Development of Edinburgh's sewage disposal scheme

A. S. CROCKETT & J. DUGDALE

DISCUSSION

Fig. 21. Details of diffuser head

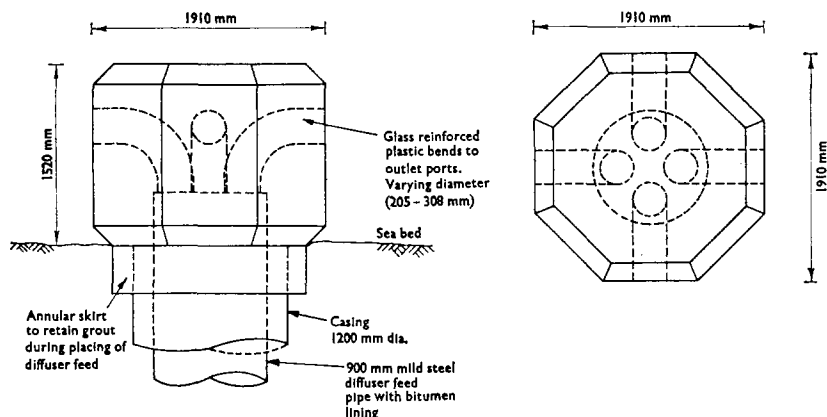
102. Regarding the outfall, perhaps the Authors could give more details of the diffuser heads, especially with reference to materials selection and the possibility of damage by shipping.

122. With regard to maintenance of the diffuser system, the design of the ports in the diffuser heads has been made as simple as possible with the port linings of glass reinforced plastic to give a reduced adhesion for marine growths, and the required frequency of maintenance is expected to be very low.

139. The diffuser system on the effluent outfall consists of nineteen heads with four diffuser ports and a further one, the outermost, with six ports. The details of a diffuser head are given in Fig. 21. Damage of the heads by anchoring of shipping must always be a possibility but we think the risk is very slight. The area concerned is not one where shipping approaching Leith Docks tends to anchor and buoys have been placed at either end of the diffuser section to warn against lying at anchor in this area. The shape of the diffuser heads is also aimed at reducing the risk of an anchor lodging against them.
